BOARD OF HEALTH

Minutes of Board of Health Meeting
October 19, 2010

Mandarin Westboro – Variance Request

MANDARIN, WESTBOROUGH

SK-21b SUSHI BAR AXONOMETRIC

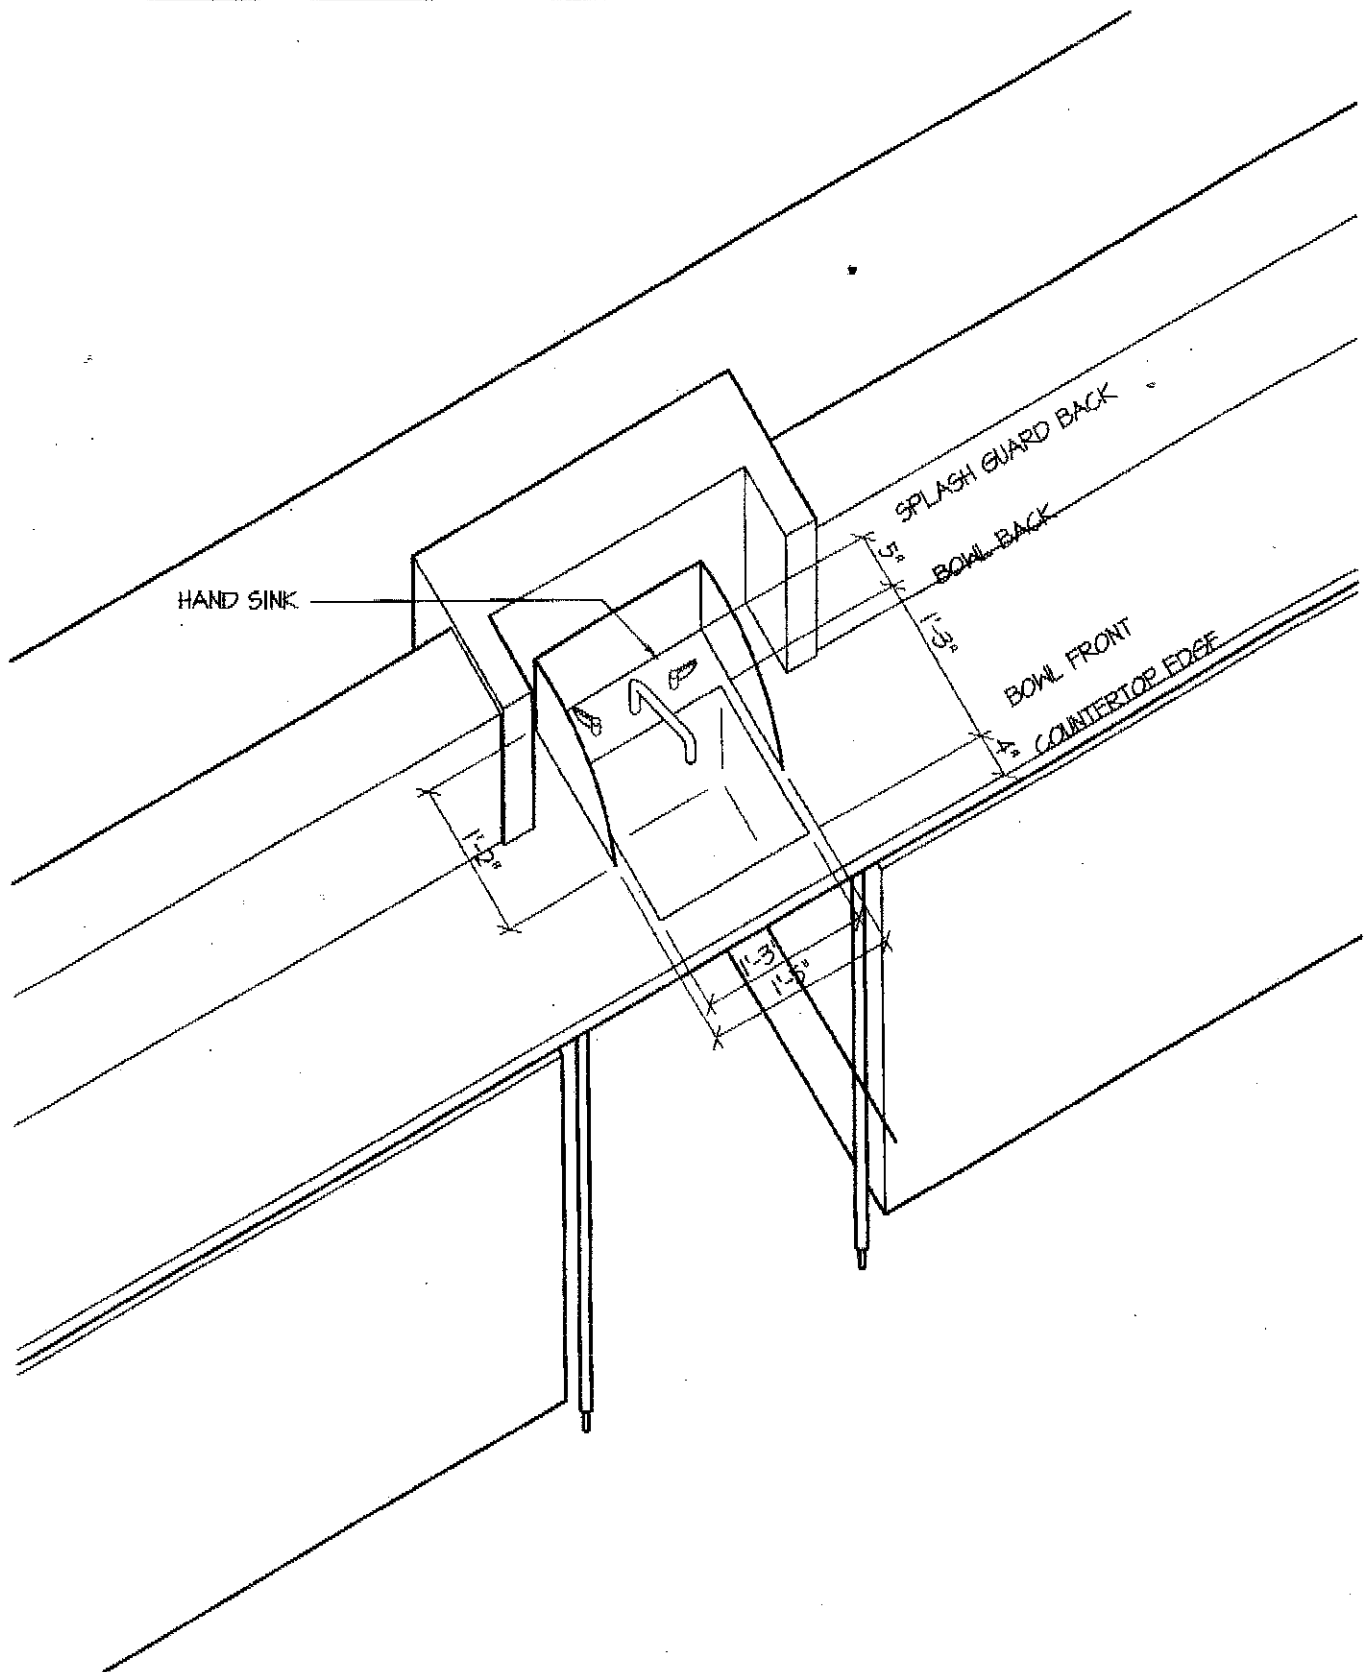
The Health Inspector explained the restaurant plans to install a sushi bar with a stainless steel preparation counter. The counter will have two integrated hand sinks, along with an integrated fish washing sink with the work counter. The two hand sinks will be separated from the stainless steel prep area with integrated stainless splash guards that will surround the sink on three sides to prevent cross contamination. The Board's current regulations require hand sinks to be wall-hung and does not allow hand washing sinks to be part of a counter space or be installed directly adjacent to food prep counters or work tables. She said the splash guards will come out approximately 14 inches and that should prevent any water splashing into the food. Two sketches of the proposed preparation counter were displayed (sketches attached.).

Director McNulty said you don't want the guards to come up too high and out on a small sink so that it becomes awkward to maneuver; it does not become conducive to good hand washing. You want the guard to come out far enough to prevent splashing, but not so far that people don't want to use it.

Health Inspector said she feels that if they come up far enough on the splash guards, they should be able to comply with the regulations.

Mr. Foo said this proposal is more sanitary and safer since the chefs will not be walking from the work area to a separated hand sink and possibly dripping onto the floor in the process.

Member Federici made a motion to grant the variance to the Mandarin from the Board's current regulations regarding hand-washing sink specifications. The motion was seconded by Chairman Ehrlich; the vote was unanimous.
